Access Compliance Report Public Rights-of-Way (Curb Ramps)

Main Street: N/A Cross Street: GARZA_AVE Location: NW

ADA ID: RPAT220202102043 Ramp Type: Type 4 - Parallel Initial Pass/Fail: Pass Overall Compliance: No Severity Score: 0

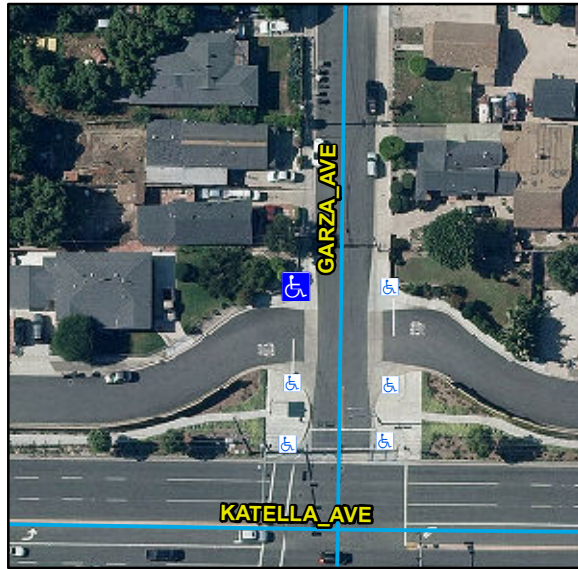
Remove & Replace Landing. Remove & Replace Gutter.
